The Commission has issued the enclosed Amendments Nos. 137, 137, and 134 to Facility Operating Licenses Nos. DPR-38, DPR-47 and DPR-55 for the Oconee Nuclear Station, Units Nos. 1, 2 and 3. These amendments consist of changes to the Station's common Technical Specifications (TSs) in response to your request dated December 19, 1984, as supplemented on March 8, 1985.

These amendments revise the TSs to support the operation of Oconee Unit 2 at full rated power during the upcoming Cycle 8. The amendments change the following areas:

1. Rod Position Limits of TS 3.5.2; and
2. Power Imbalance Limits of TS 3.5.2.

SAFETY EVALUATION BY THE OFFICE OF NUCLEAR REACTOR REGULATION

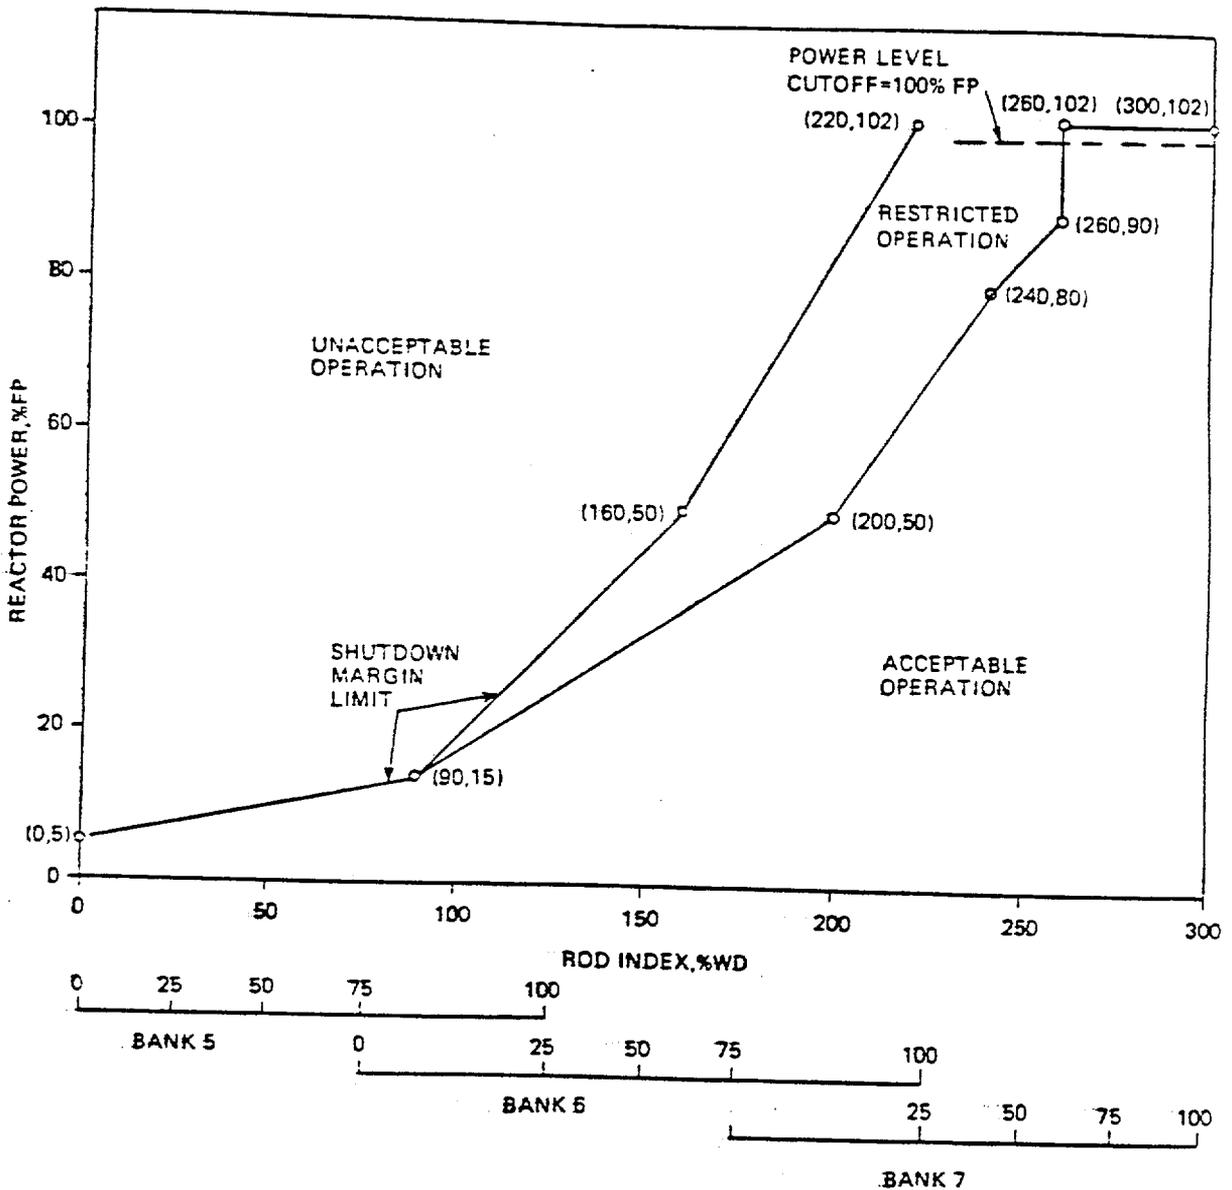
The specified flow rates of Figure 2.1-3B correspond to the expected minimum flow rates with four pumps, three pumps, and one pump in each loop, respectively.

The curve of Figure 2.1-1B is the most restrictive of all possible reactor coolant pump-maximum thermal power combinations shown in Figure 2.1-3B.

The maximum thermal power for three-pump operation is 88.07 percent due to a power level trip produced by the flux-flow ratio 74.7 percent flow x 1.07 = 79.92 percent power plus the maximum calibration and instrument error. The maximum thermal power for other coolant pump conditions is produced in a similar manner.

For each curve of Figure 2.1-3B, a pressure-temperature point above and to the left of the curve would result in a DNBR greater than the CHF correlation limit or a local quality at the point of minimum DNBR less than the CHF correlation quality limit for that particular reactor coolant pump situation. The curve of Figure 2.1-1B is the most restrictive of all possible reactor coolant pump-maximum thermal power combinations shown in Figure 2.1-3B.

Figure 3.5.2-2
(1 of 1)

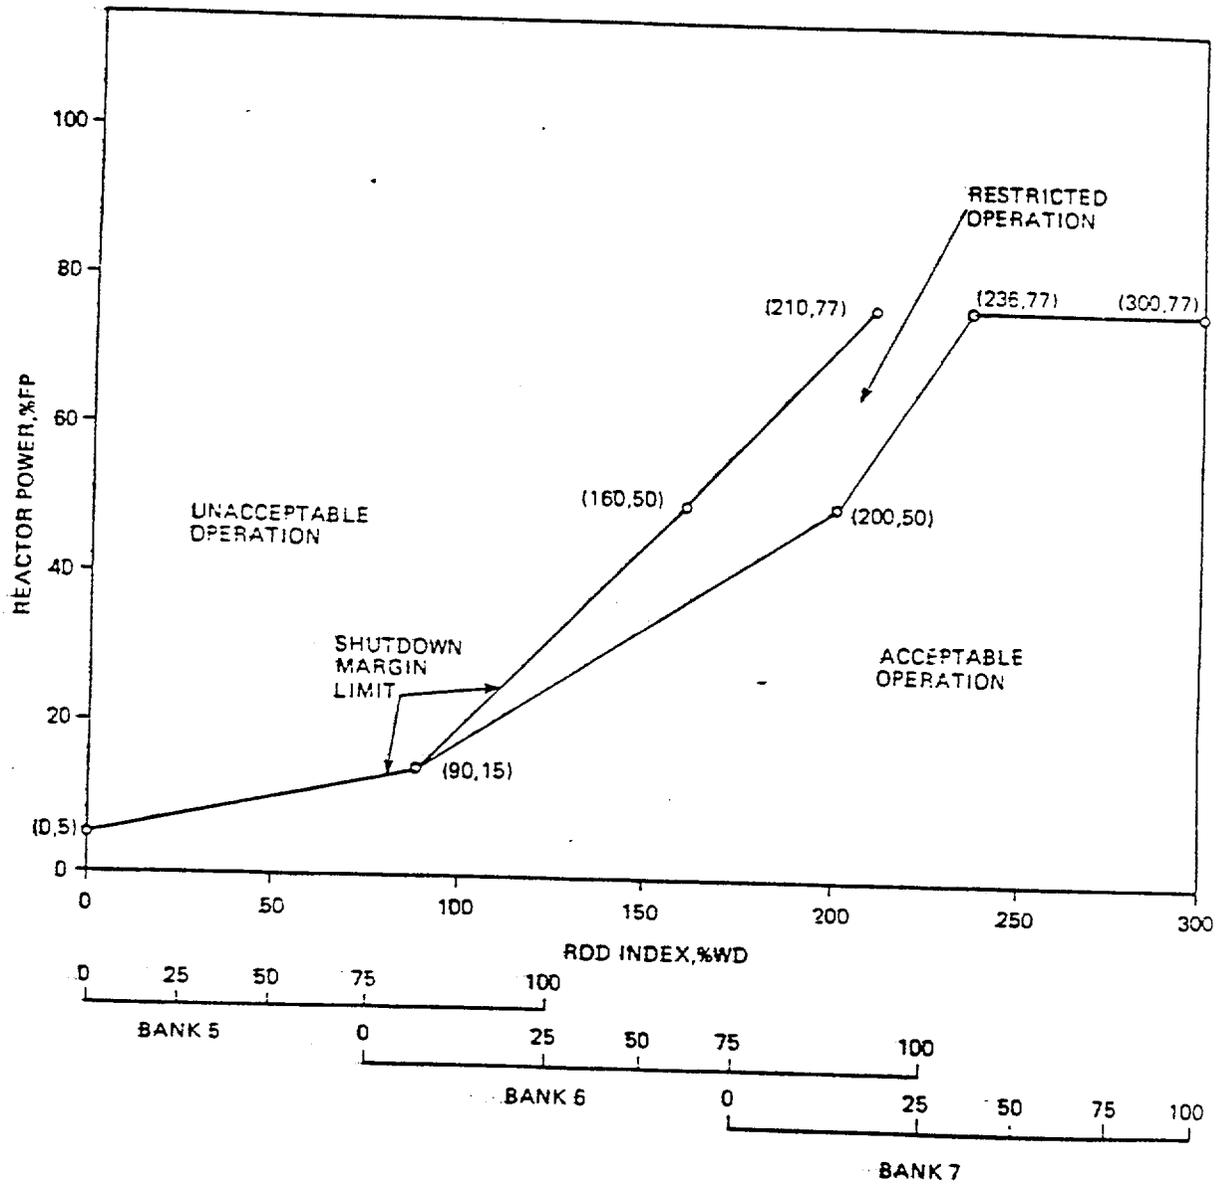
ROD POSITION LIMITS
FOR FOUR PUMP OPERATION
FROM 0 EFDP TO EOC
UNIT 2.

1. Rod Position Limits of TS 3.5.2, and
2. Power Imbalance Limits of TS 3.5.2.

Figure 3.5.2-5

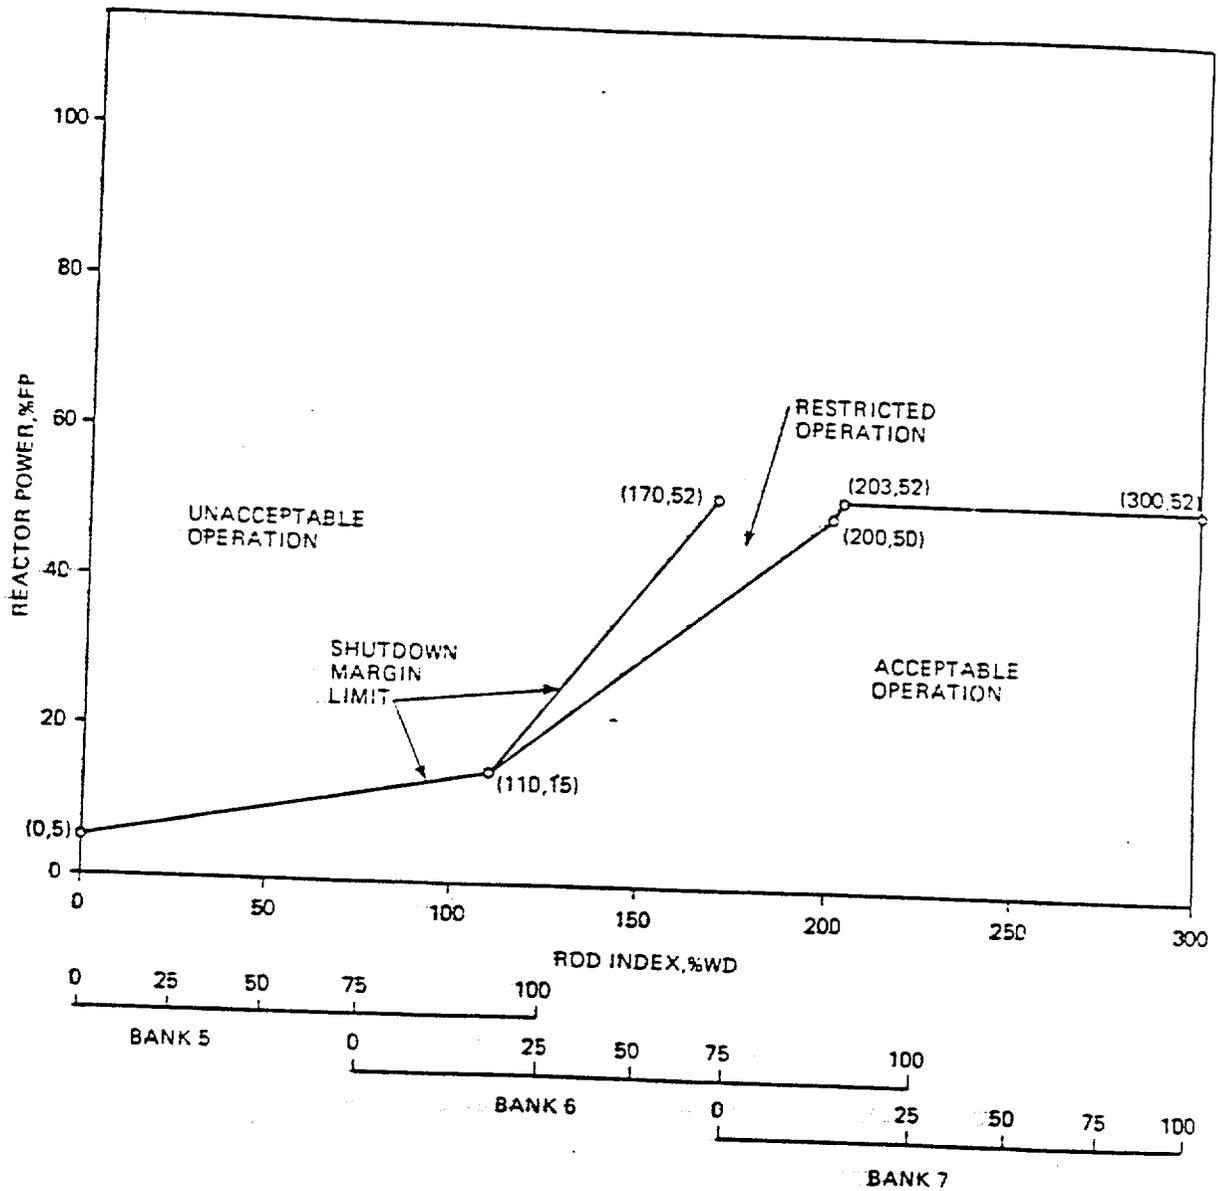
ROD POSITION LIMITS
FOR THREE PUMP OPERATION
FROM 0 EFPD TO EOC
UNIT 2

Figure 3.5.2-8
 (1 of 1)

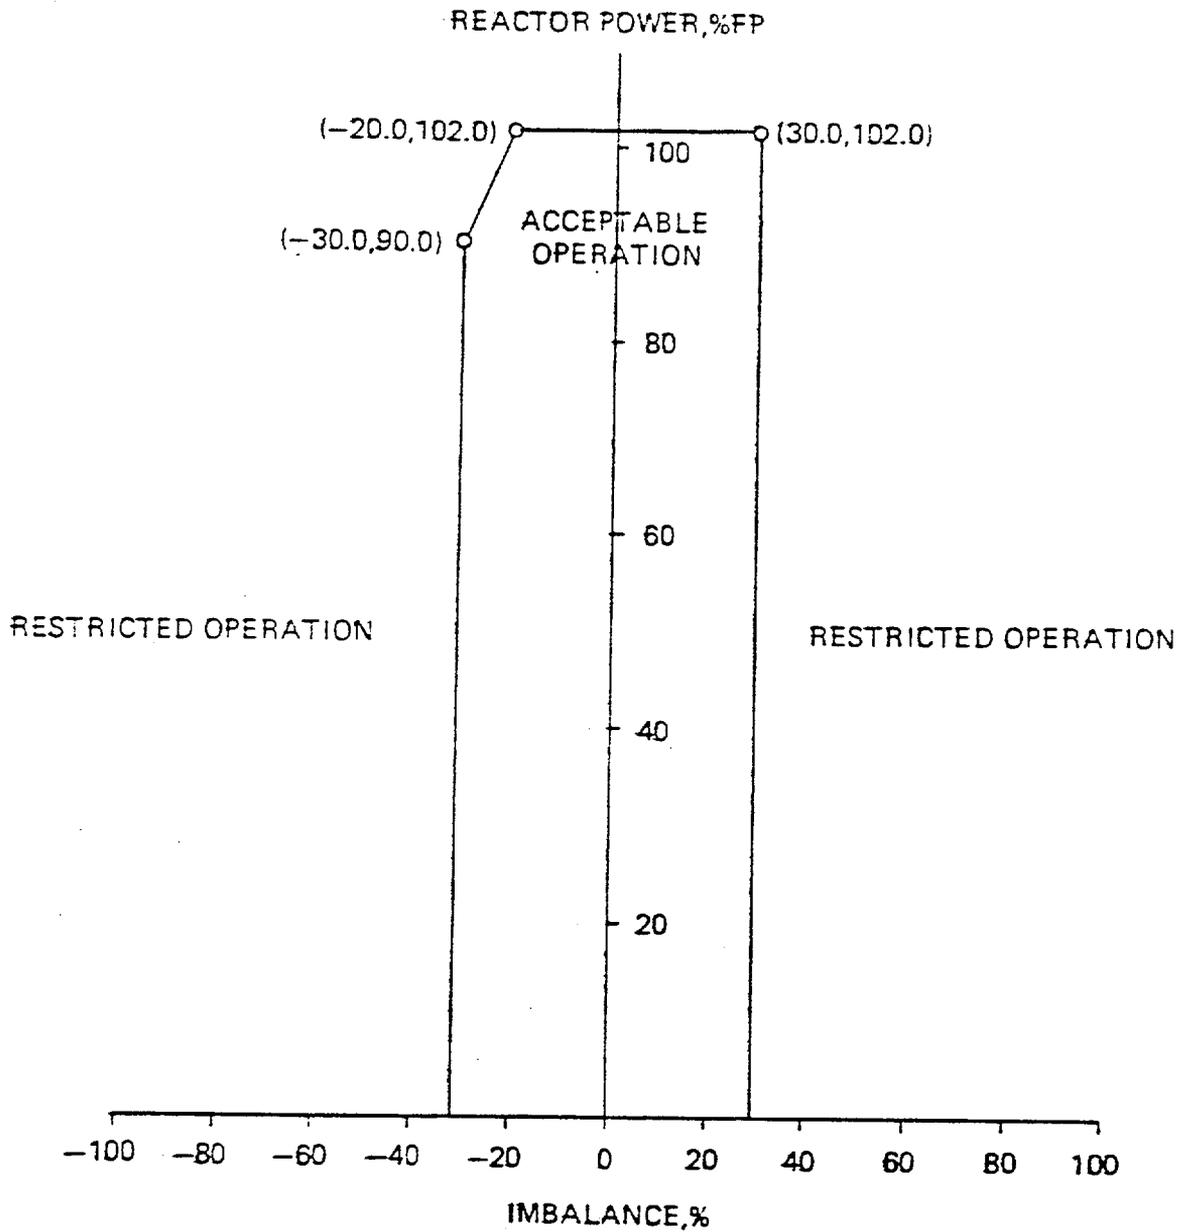
ROD POSITION LIMITS
 FOR TWO PUMP OPERATION
 FROM 0 EFPD TO EOC
 UNIT 2
